CERTIFICATE OF APPROPRIATENESS PLACARD

410 Glenwood Ave

COA-0148-2025

Material and Detail Modifications to Previously-Approved COA

Loggia Elevation

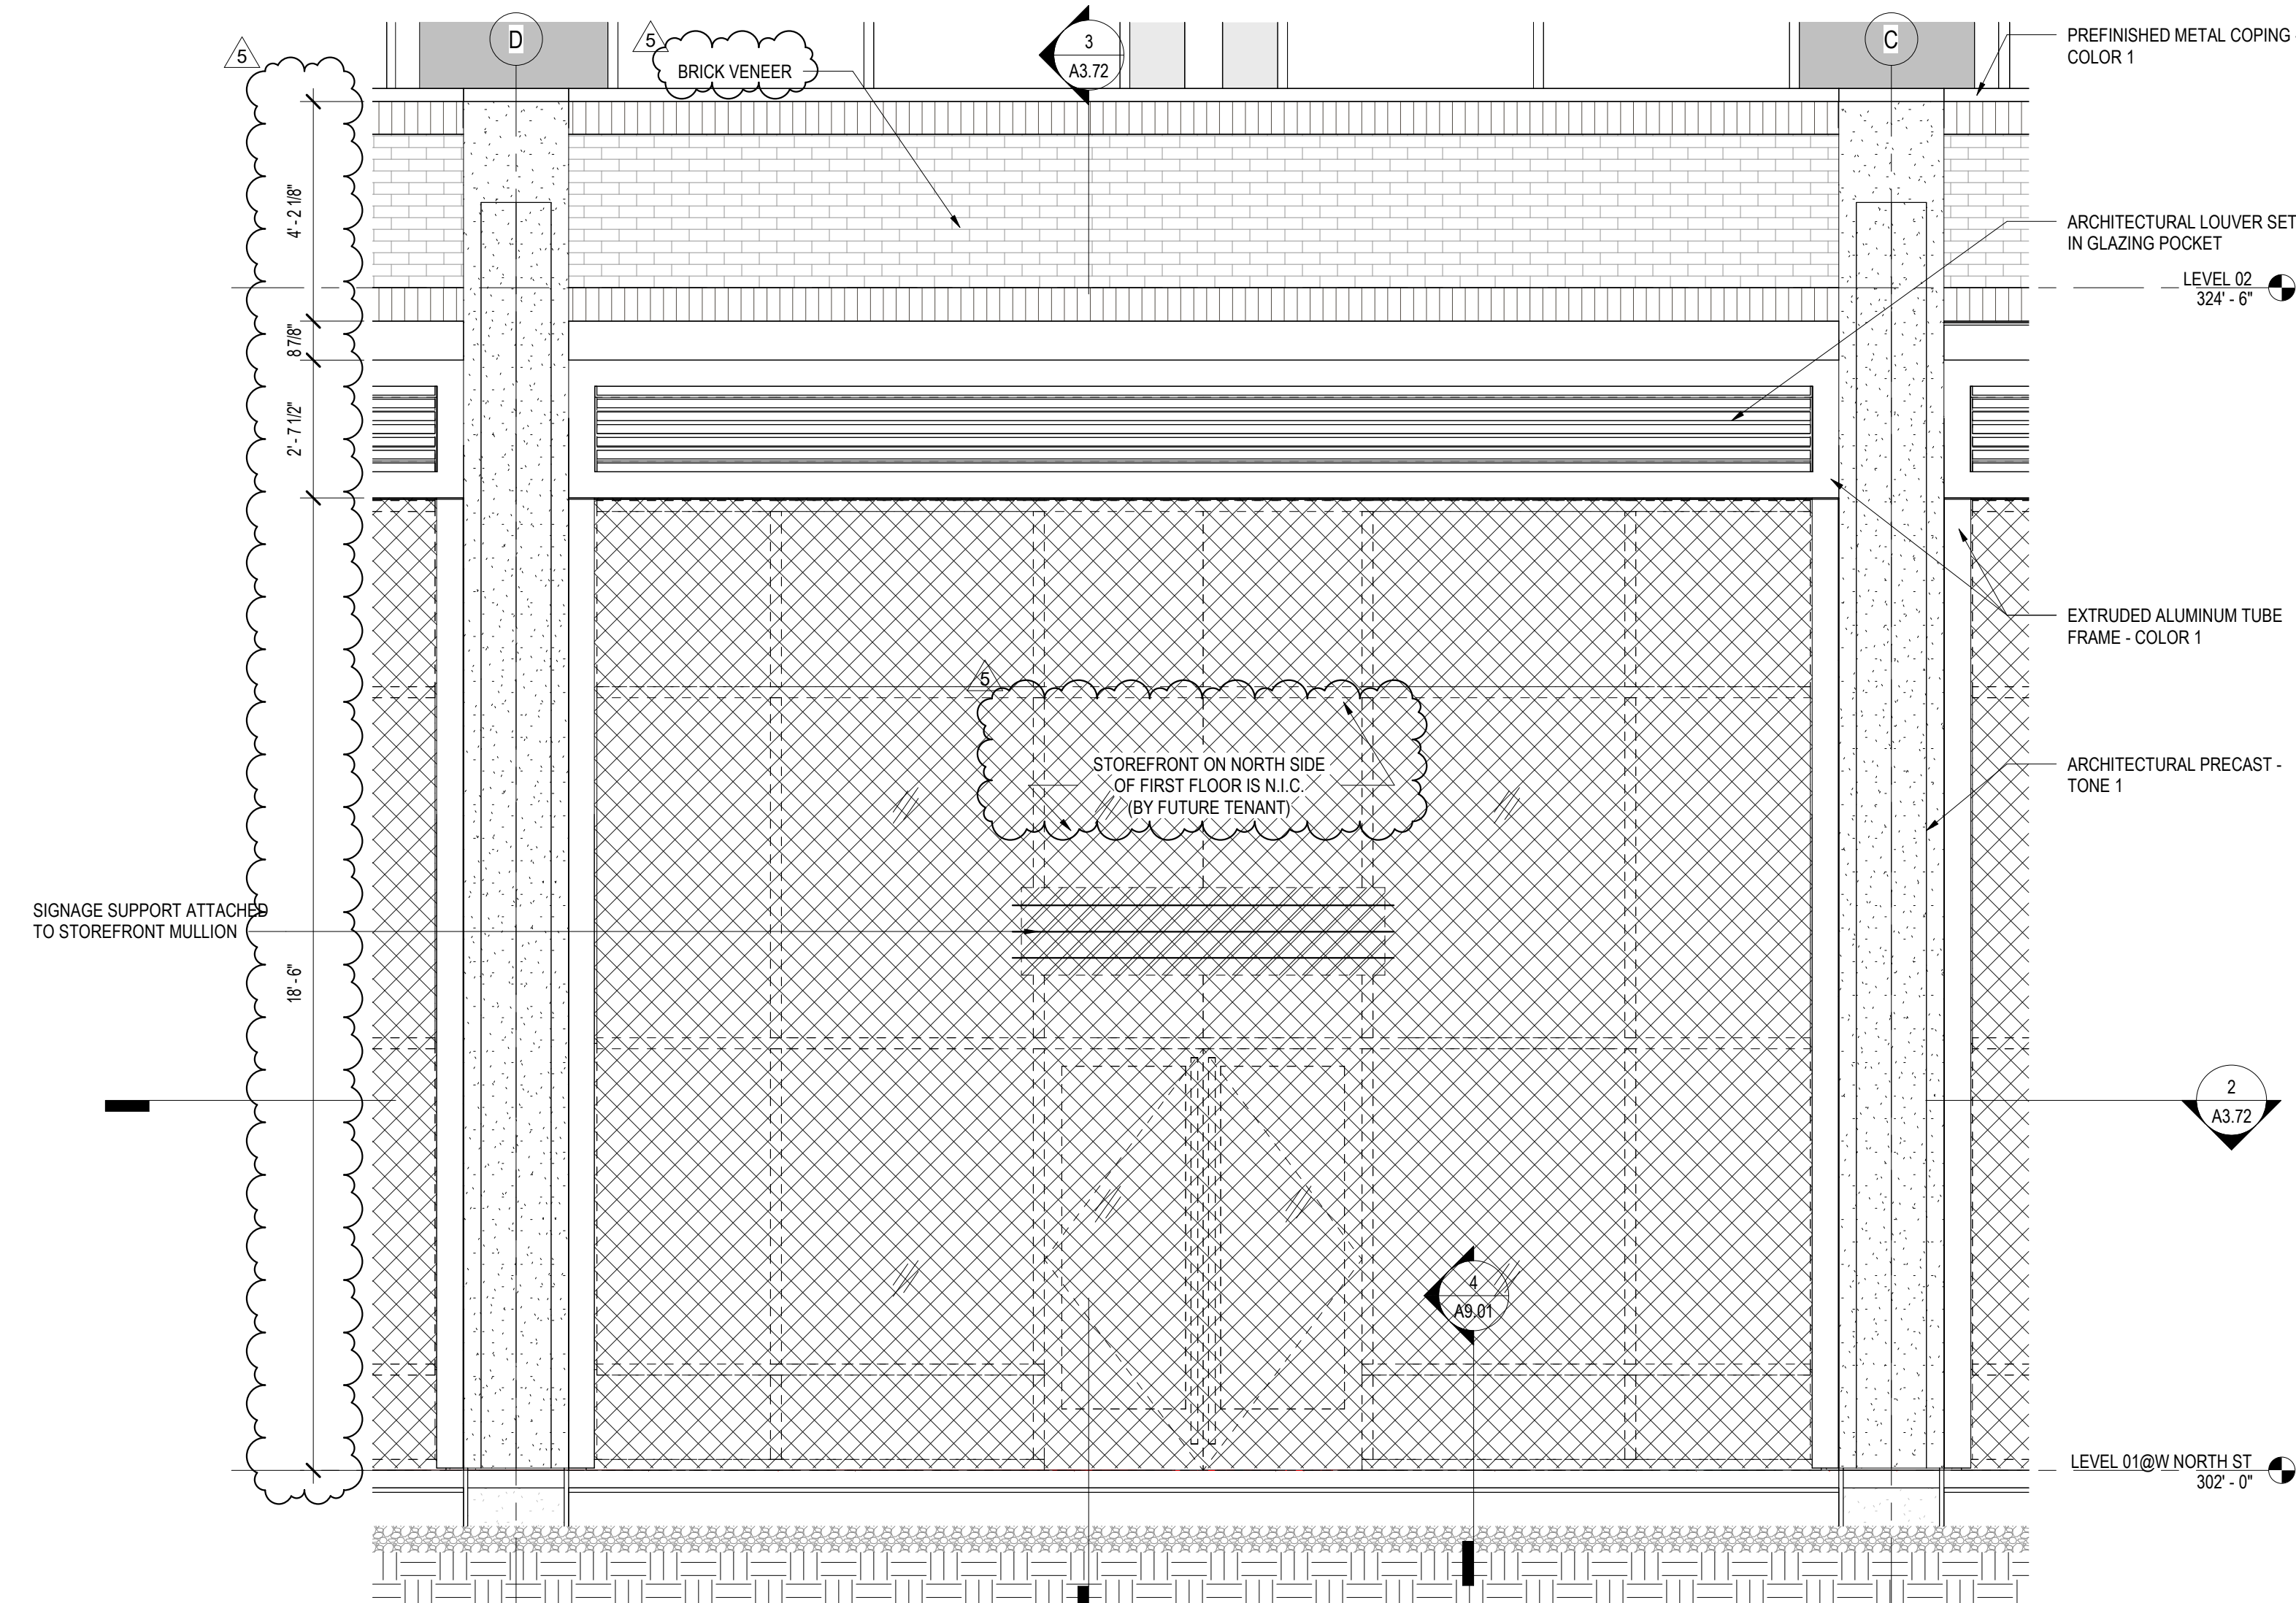
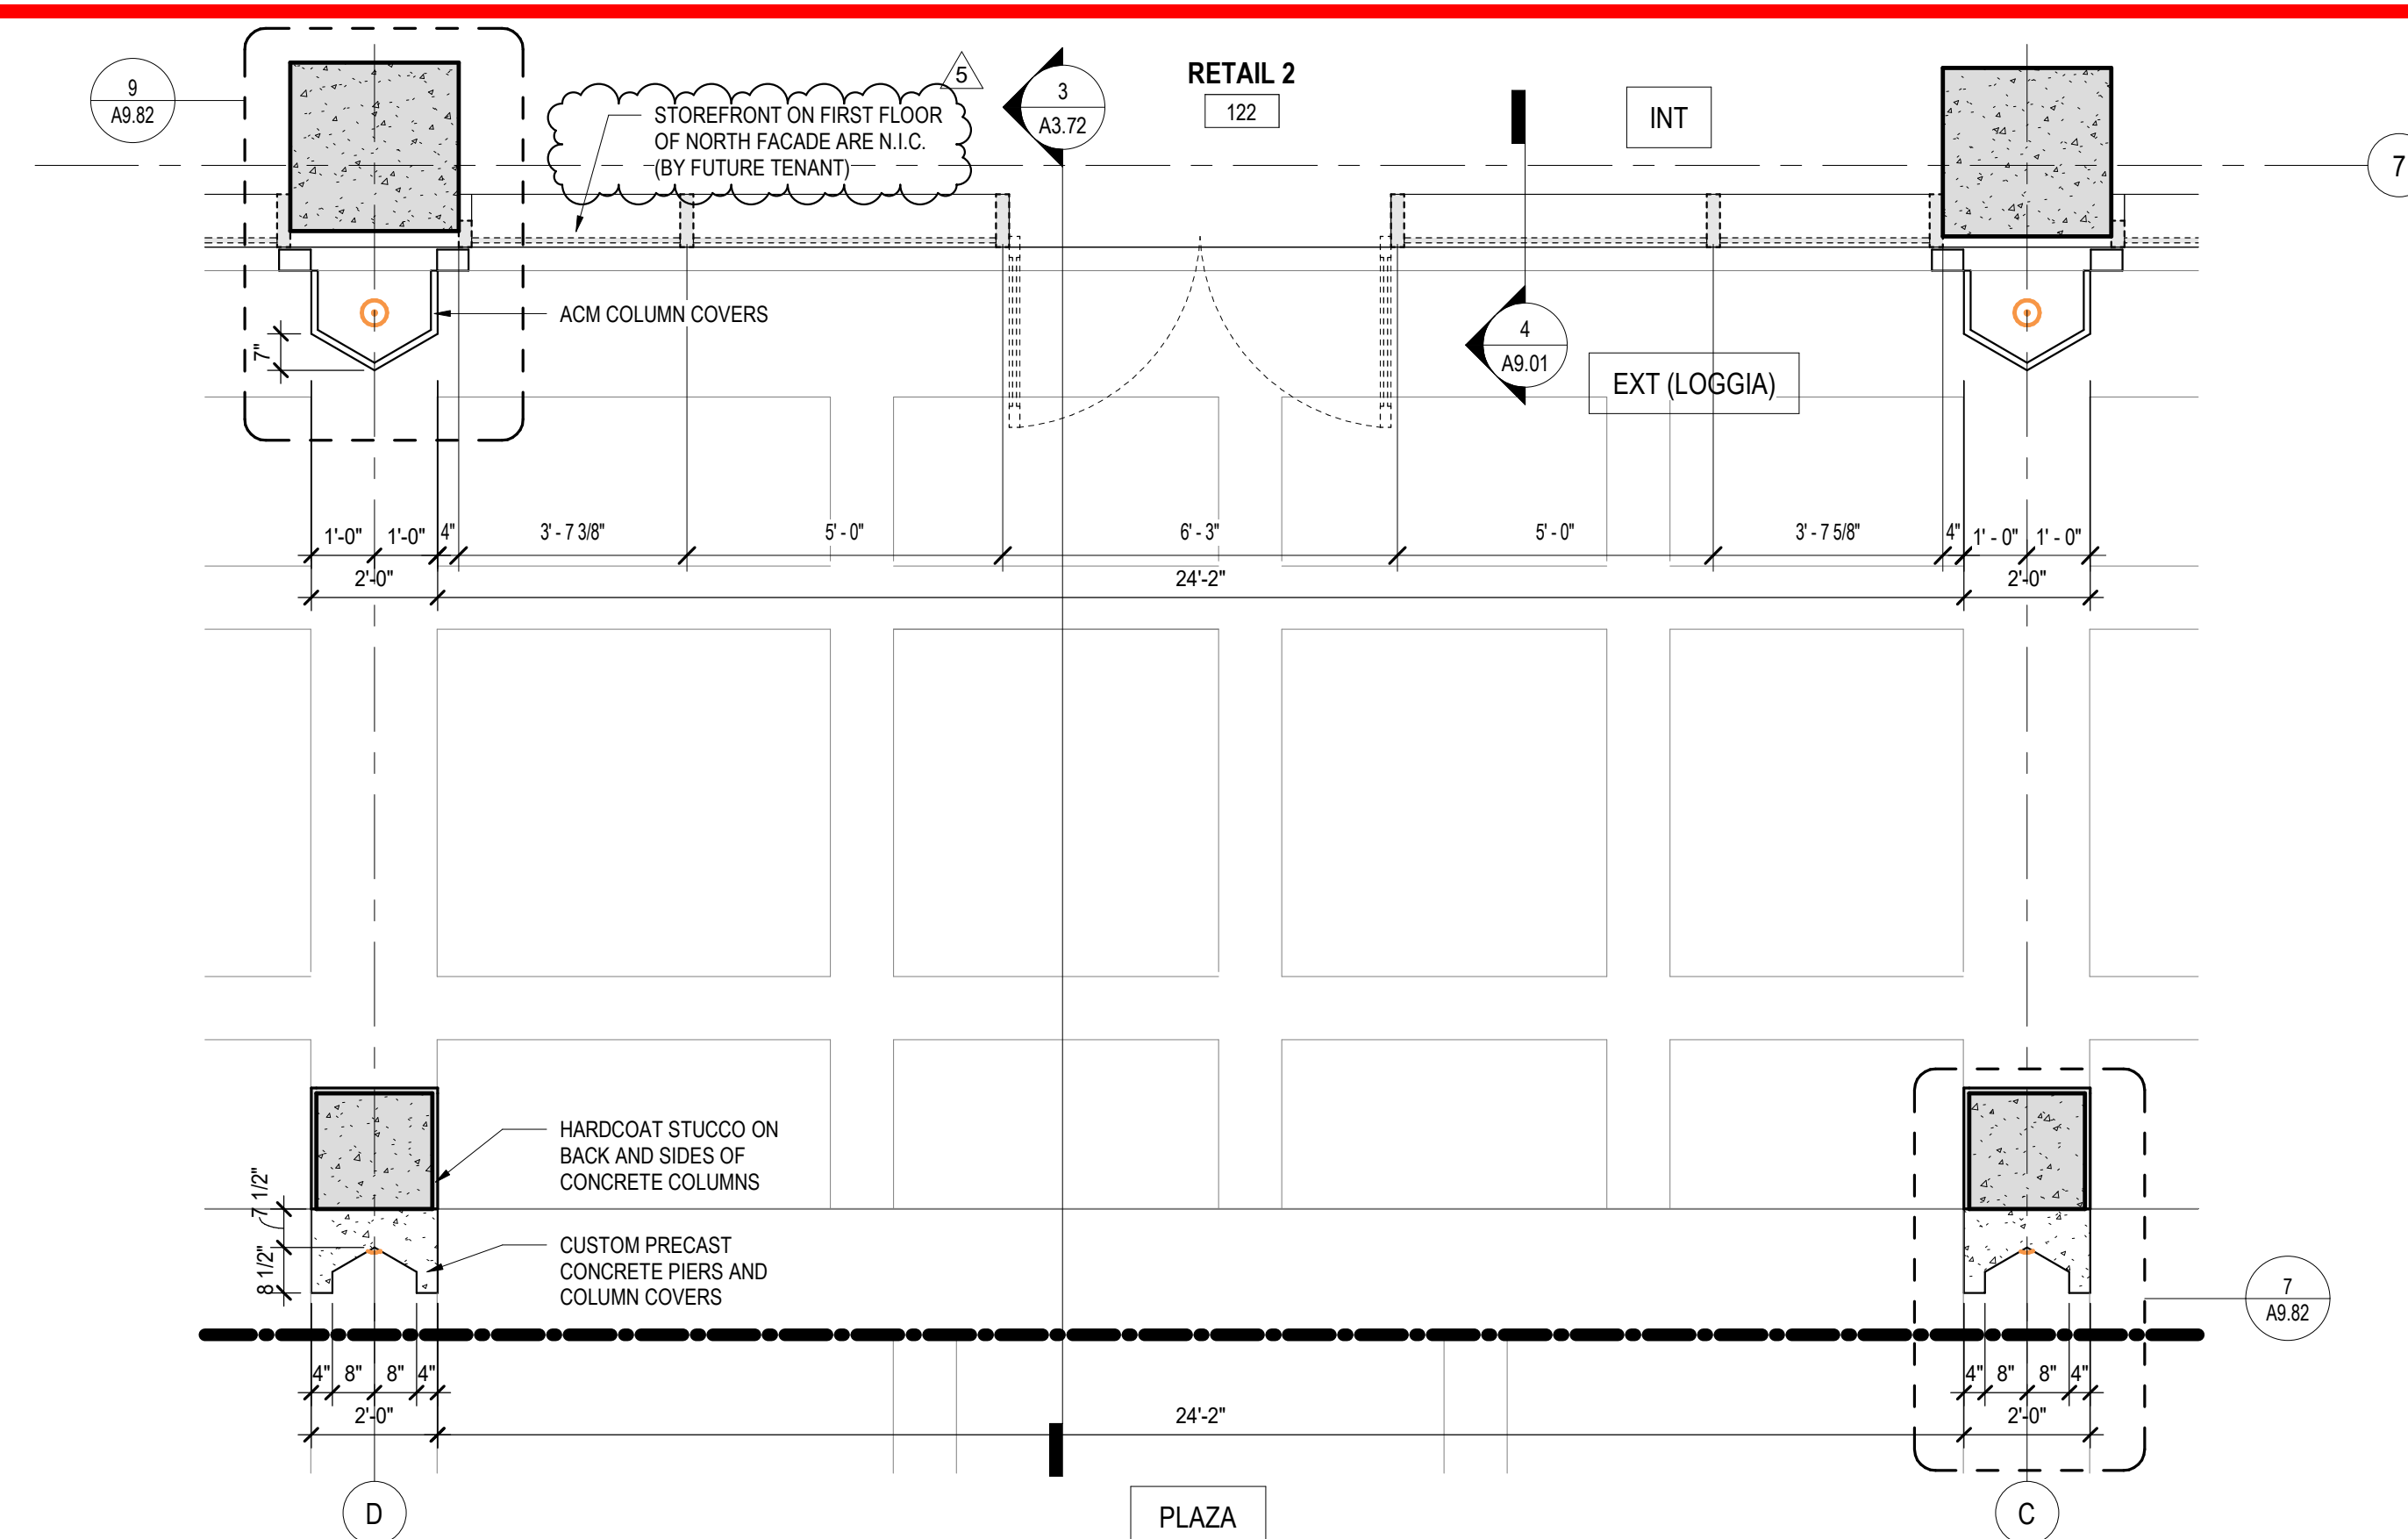
1. Minimal modifications to the loggia include:
 - The precast concrete frame and the five associated bay sizes remain consistent with the previously-approved COA. The details of the precast loggia columns remain consistent with the previously-approved COA.
 - To maximize the amount of glazing at the street level storefront, the signage band has been removed and the louver band required to meet HVAC requirements has been shifted from the building wall to the fascia. To accommodate the louvers while maintaining consistency with the massing and proportion of the previously-approved design, the parapet wall has been revised from steel railing to brick.
 - At the fascia, the previously-approved blue glazed brick has been revised to buff colored brick to match the new brick used elsewhere in the project.

1. Side-by-side rendered elevations for the previously-approved and currently proposed elevation illustrates these modifications.
2. Architectural drawing 1/A3.72 illustrates a typical loggia bay and 4/A3.72 shows the storefront at the building wall behind the loggia. Architectural drawing 3/A3.72 illustrates the section cut through the loggia.
3. A graphic material key shows material colors and selections for the building.
Material samples and colors will be delivered to the RHDC office.
